No: PCB/ Ramanagara/ Mother Earth/ NGT/WMC/2021-22/110 DATE: 20/9/2021

**Inspection Report of Sri Vasudeva S.K, SEO, Zonal Office, KSPCB ,Bangalore South.**

1	Name and Address of the TSDF inspected	Mother Earth Environ Tech Pvt. Ltd Plot No.217, KIADB Industrial Area ,2 <sup>nd</sup> Phase, Harohalli, Kanakapura Taluk, Ramanagara District
3	Category and classification	Small Size Landfill site less than 5 hectares (4 Acres)- Large- Red
4	Person's Contacted	Sri Renukaradhya, Senior Manager Tech & operations & operations and Sri Sanjay Gowda – In charge
5.	Date of inspection.	20.09.2021
6.	Consent and authorization status	Having valid consent under Water and Air Acts for the period up to 30.06.2021 and also authorization under HWM Rules,2016 for the period up to 30.06.2021

The TSDF have provided green belt of different species of saplings

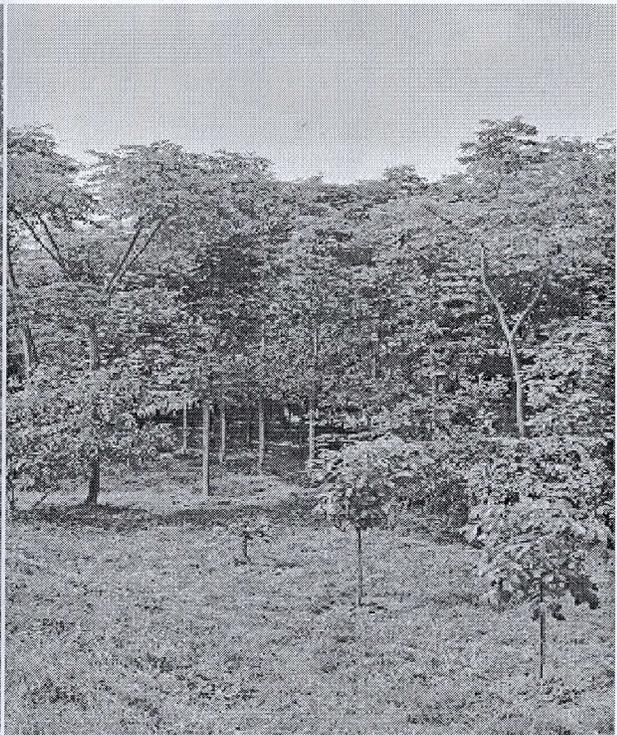
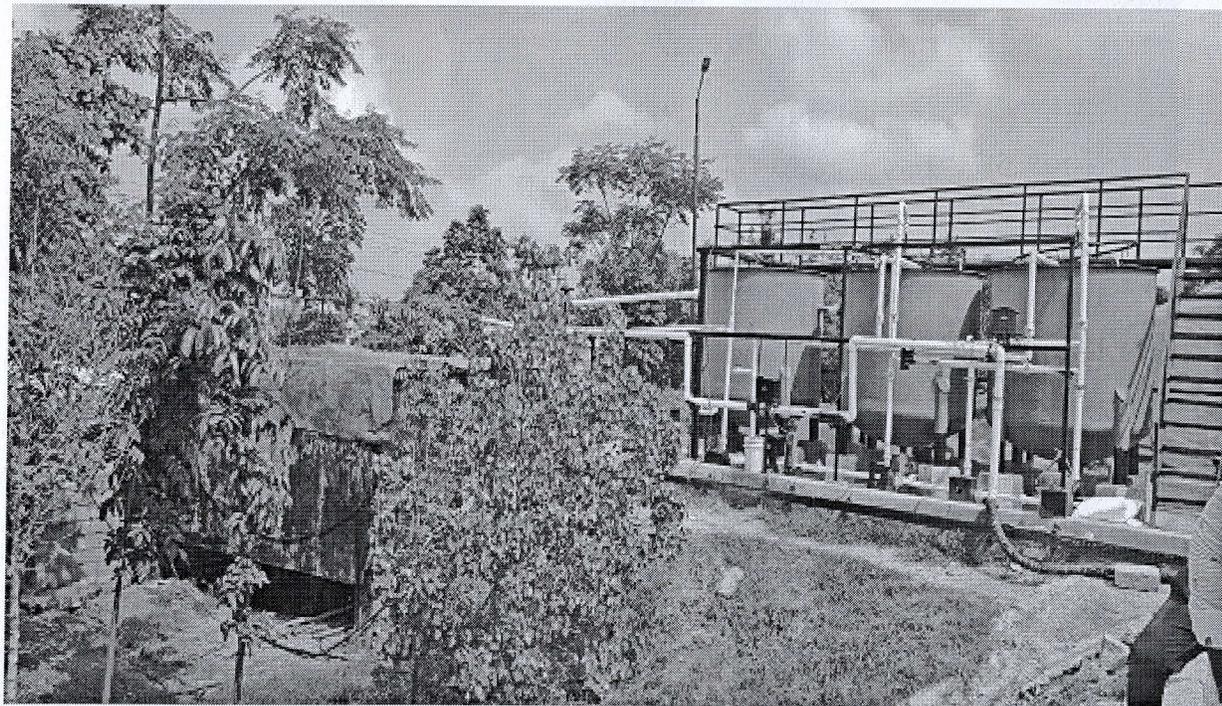
Alleged Violations	Page No. and Para No.	Observations made during the time of inspection
Green belt of 15m shall be provided all along the periphery of the site/ 33% of the total project area.	Page No. 8 and Para No.5.2	The TSDF authorities have developed green belt area consisting of different species of saplings of width about 15 m on East, 15 m on the North, 3.5 m on the west up to cell-1 length and 17 m for cell-2 length and maintained greenery all along the boundary of the TSDF (Maintained overall 33% of the total project area).
Regular online monitoring of all the ambient air quality and water quality shall be carried out	Page No. 8 and Para No.5.2	This is small TSDF with an area of < 5 acres. For this area one Continuous Ambient Air quality station could have been installed. However, authorities have not installed Continuous Ambient Air quality monitoring station. Instead, the TSDF authorities have entrusted monitoring of Ambient Air Quality to MoEE & CC accredited laboratory and submitting the reports to the Board.

The TSDF provided leachate pre treatment unit of capacity 15KL above ground level consisting of 2 numbers of neutralization tank followed by settling tank and final collection tank

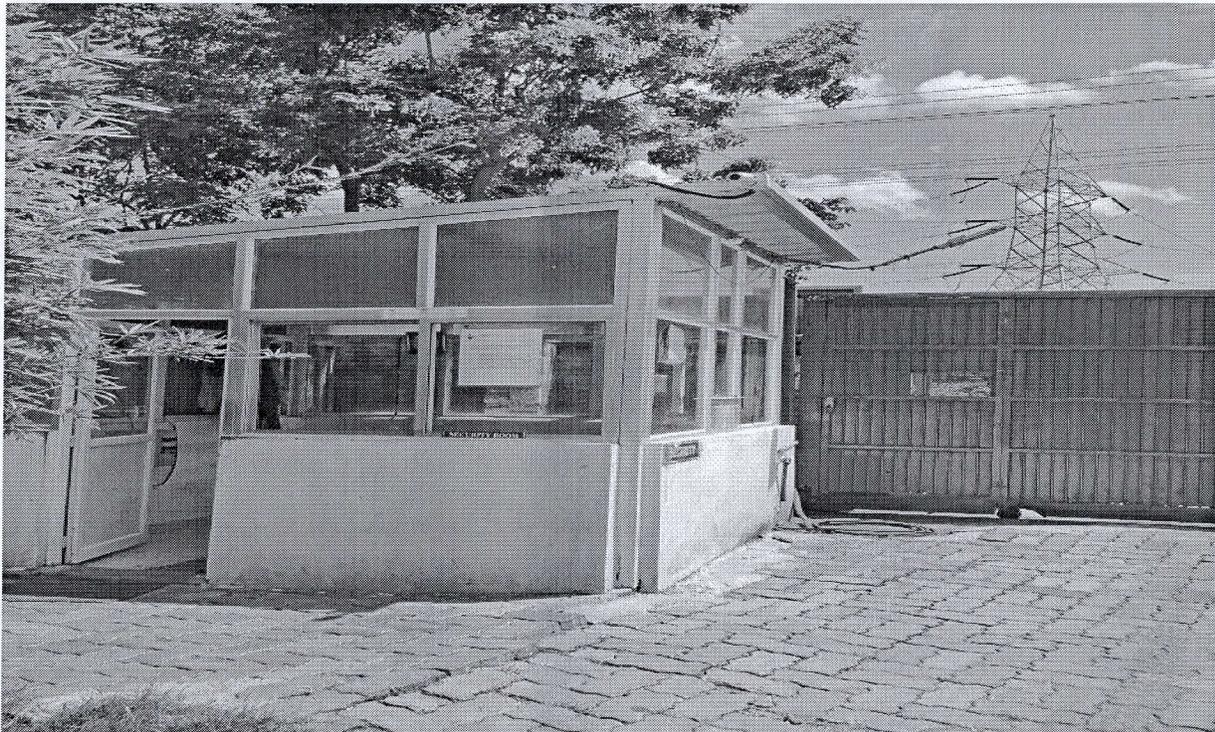
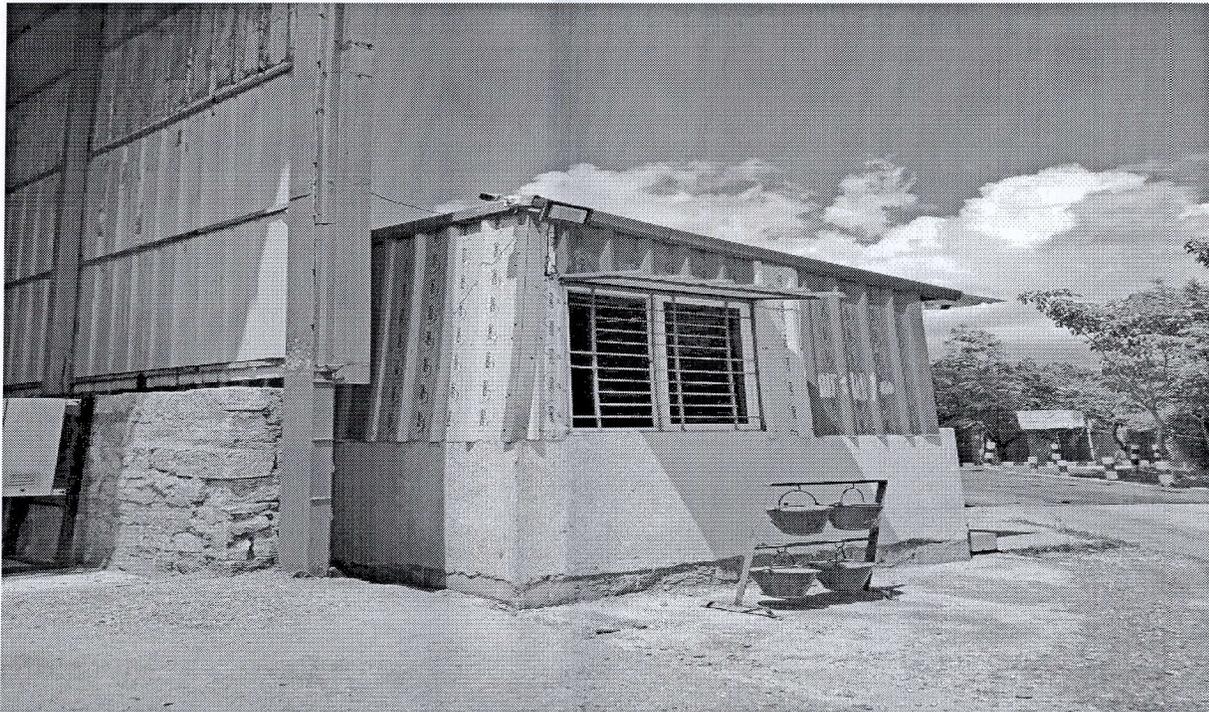
Non-compliance to the conditions of Consent for Operation referred in the Joint Committee Report		
Domestic effluent (0.4KLD) shall be treated in septic tank & soak Pit	Page No. 9 and Para No.5.3	The TSDF authorities have employed about 20 numbers and the domestic effluent generated is being treated in septic tank & soak pit. No over flow Soak pit was noticed during the time of inspection.
Leachate from cells, tyre wash water(2.0) shall be handed over to CETP M/s Govind Solvents Pvt Ltd for further treatment & disposal	Page No. 9 and Para No.5.3	The trade effluent (leachate & tyre wash effluent) was being sent to CETP after pre-treatment. They have provided new leachate pre treatment unit of capacity 15KL above ground level consisting of 2 numbers of neutralization tank followed by settling tank and final collection tank. The pre treated leachate was disposed to CETP of Govinda Solvents Pvt Ltd

and Bangalore Eco Park Pvt Ltd and maintaining records and also submitting the monthly manifest copies to the Board. Photos of primary treatment plant are enclosed. This is inline with the Combined Consent for Operation issued by the Board.
Shall install Multiple Effect Evaporator (MEE) for disposal of Leachate generated from the waste with in 6 months	Page No. 9 and Para No.5.3	The condition stipulated in combined consent order dated: 13.04.2016 (issued through manually) & 14.06.2016(Corrigendum to CFO order) to install Multiple Effect Evaporators (MEE) has been modified by the Board vide Board Office Corrigendum Order No.6857 dated: 08.03.2017 (Copy enclosed). Due to above, the disposal method followed is in line with CFO conditions. However, the operator of the facility has not obtained amendment for enhancing the quantity of pre-treated trade effluent including leachate being handed over to CETP.

The TSDF authorities were installed web camera at the entrance of the gate and finger print sampling station

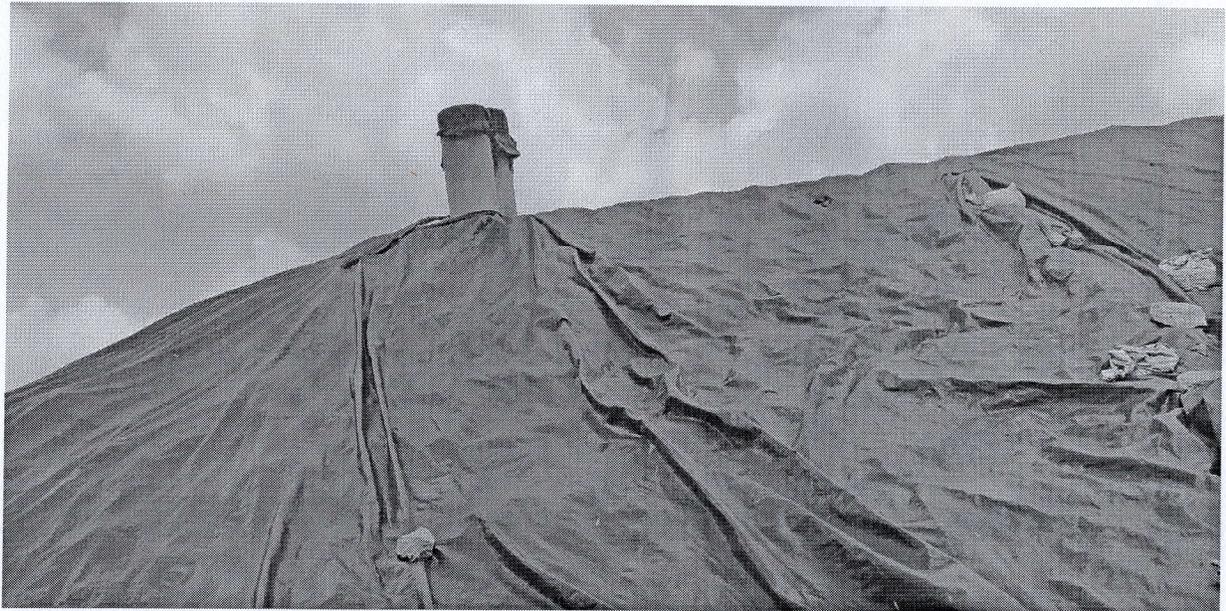
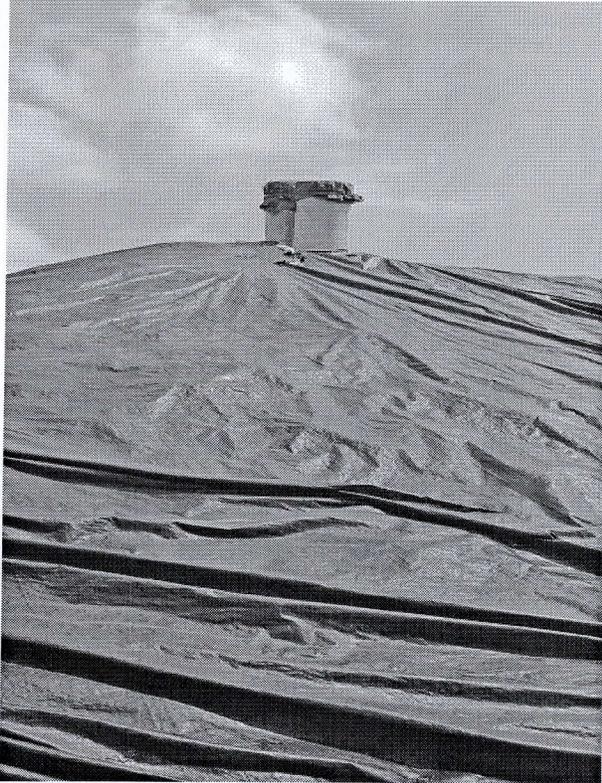
Shall install web camera at the entrance of the gate, finger print sampling station and treatment area	Page No. 9 and Para No.5.3	The authorities have installed web camera at the entrance of the gate and finger print sampling station and yet to install the camera at the treatment area (Photos enclosed). However, the same is not connected to CPCB/KSPCB server.
Shall install hood, duct& air pollution control equipmentwith chimney to the waste stabilization/processing area to control smell nuisance	Page No. 9 and Para No.5.3	The TSDF authorities have provided waste stabilization shed of size 80 m x 10 m, consisting of 3 numbers of concrete stabilization pits each of capacity 30MT along with hood, duct & blower and chimney of 15.0 m above ground level along with alkaline Scrubber as air pollution control equipment (Photographs enclosed).
Plant 3 rows of high plantation periphery and the adequate greenery.	Page No. 9 and Para No.5.3	The TSDF have provided green belt of different species of saplings of width about 15 m on East, 15 m on the North, 3.5 m on the west up to cell-1 length and 17 m for cell-2 length and maintained greenery (Photographs enclosed).

**Hume pipes inserted vertically at two locations**

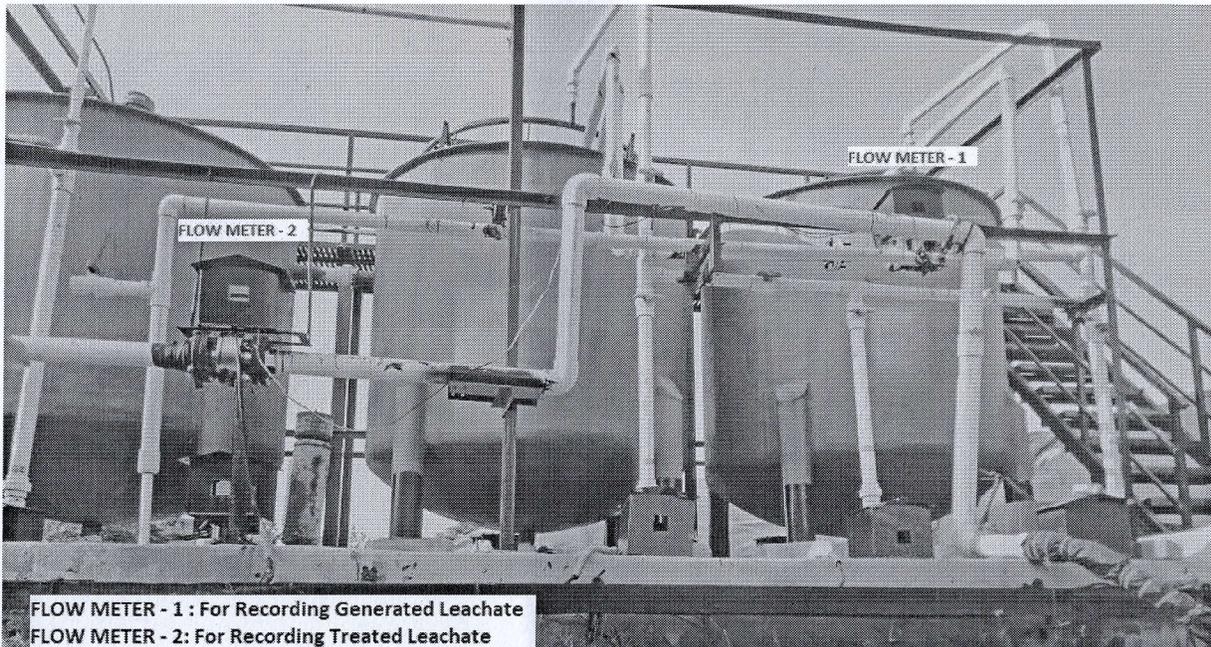
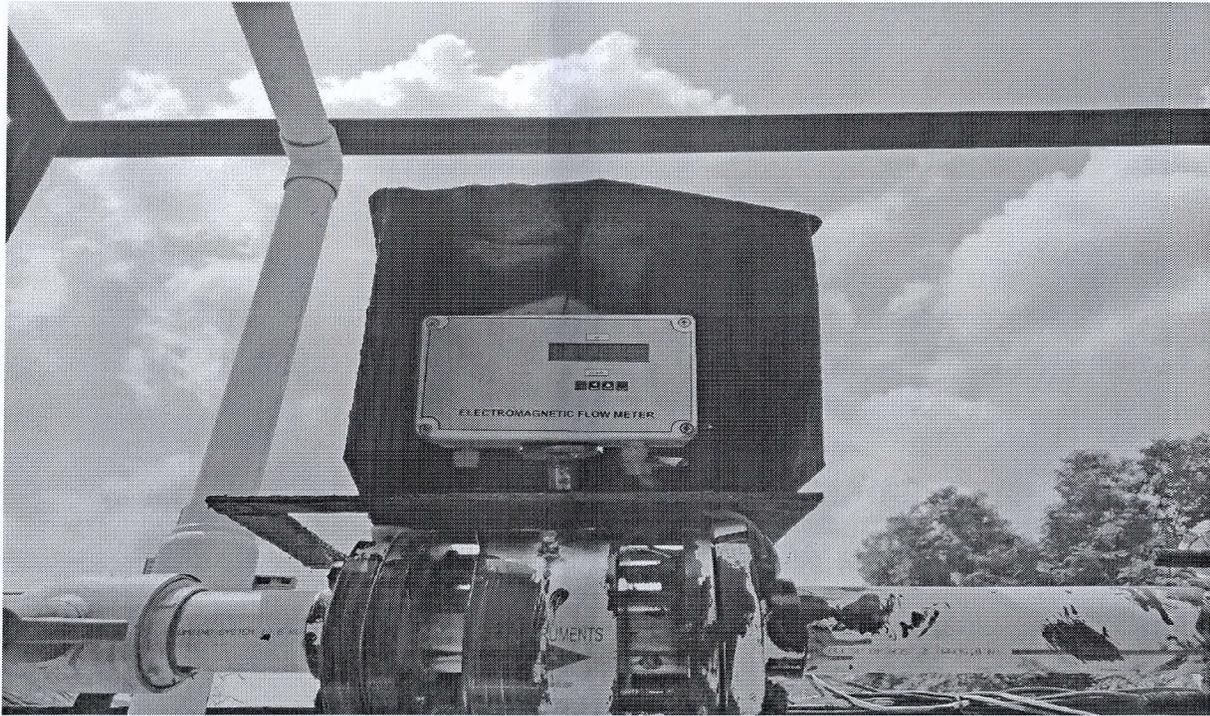
Shall provide tank in tank system for leachate collection tank to identify any leakages	Page No. 29 and Para No.7.4.1	The Board has not stipulated to provide tank in tank for collection of leachate, During inspection, it was observed that the TSDF authorities have provided concrete Hume pipe with perforation. This hume pipe is inserted vertically at two locations. It was informed that, the slope is provided in such a way that, the leachate generated in the TSDF is to flow towards the hume pipe. The leachate so collected is being pumped to collection tank for pre-treatment and further storage inside the landfill cells upto bottom (above HDPE liners) for which all lateral perforated HDPE pipes are connected to concrete hume pipes. Submersible pumps are provided ensure that the generated leachate is directly pumped to the primary treatment plant & neutralized and disposed to CETP of M/s. Bangalore Eco park or Govind Solvents Pvt.Ltd.,

The mechanical flow meters provided at the inlet and outlet of the leachate pre treatment plant and also at the surface runoff collection tank outlet

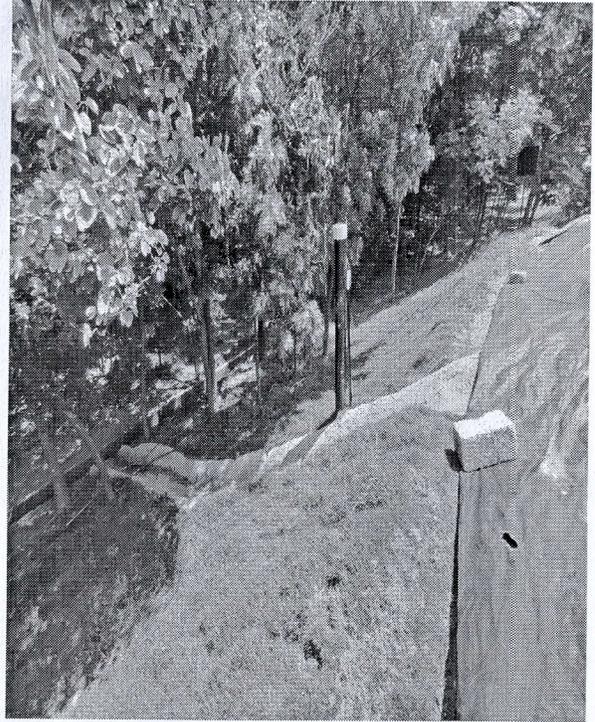
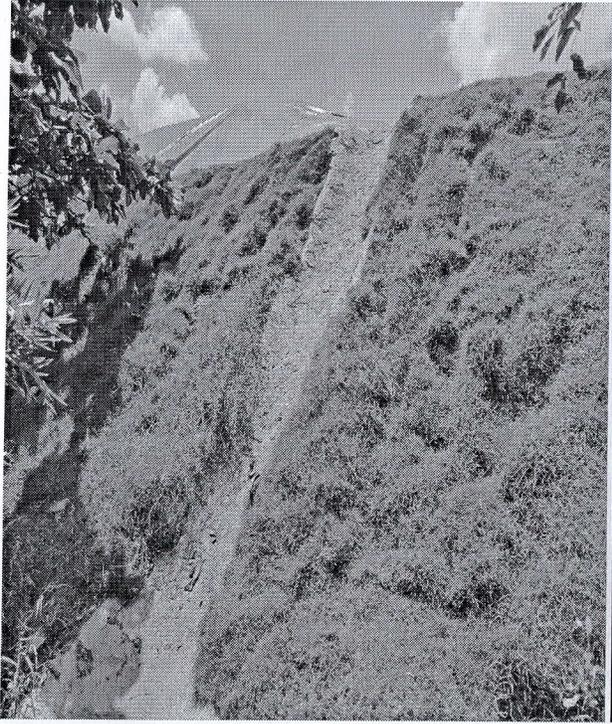
The leachate generation is double during the year 2017 to 2020	Page No. 11 and Para No.5.6	The leachate generation was doubled due to the fact that all the waste generated thought the state was being received by this TSDF only (At that time the other TSDF was closed for short period for refusal of the consent by the Board) and hence the quantity of hazardous waste generation for land filling was collected by this TSDF,  On enquiry, the operator of the facility informed that, the leachate generation has increased due to handling of enhanced quantity in a short period.
Shall install integrated flow measuring recording devices on the effluent line and a record of daily effluent discharge shall be maintained	Page No. 29 and Para No.7.4.1	The TSDF authorities have not provided integrated flow measuring recording devices on the effluent line. However, during inspection, it was observed that, the mechanical flow meters were provided at the inlet and outlet of the pre treatment plant and also at the surface runoff collection tank outlet and the records are maintained. Photographs enclosed

The TSDF authorities have provided storm water drains (garland canals) for collection of surface runoff

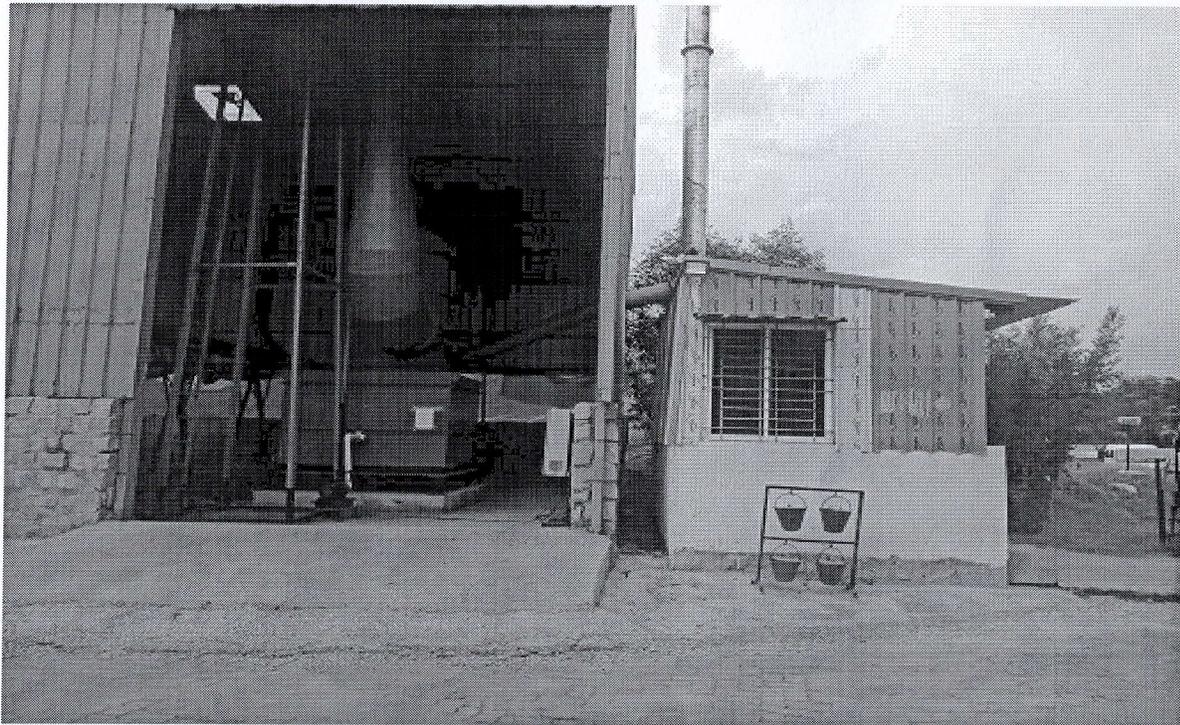
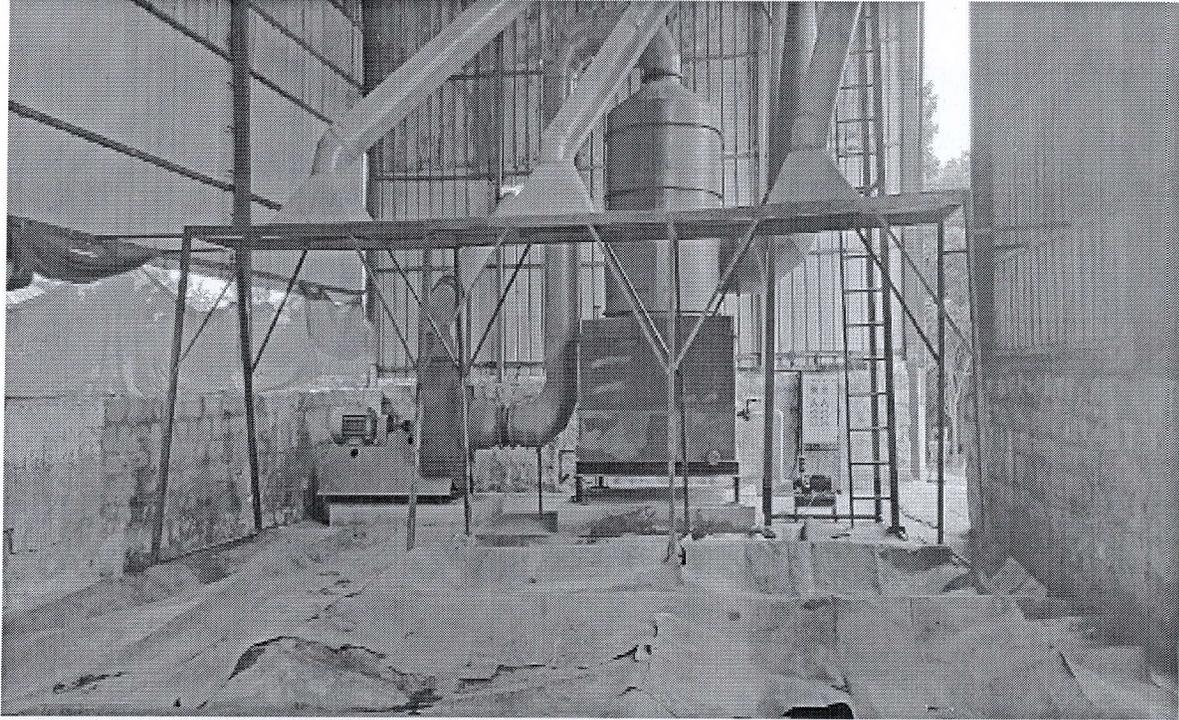
Management of surface runoff	Page No.37 and Para No.7.5	The TSDF authorities have provided storm water drains (garland canals) on East, West & North side for collection of surface runoff and they have constructed three collection tanks of capacity 30 KL, 15 KL & 50KL for collecting the storm water from the TSDF and pumping the same to the pre treatment plant/ leachate collection tank and neutralized and disposed to CETP-M/s Bangalore Eco Park.
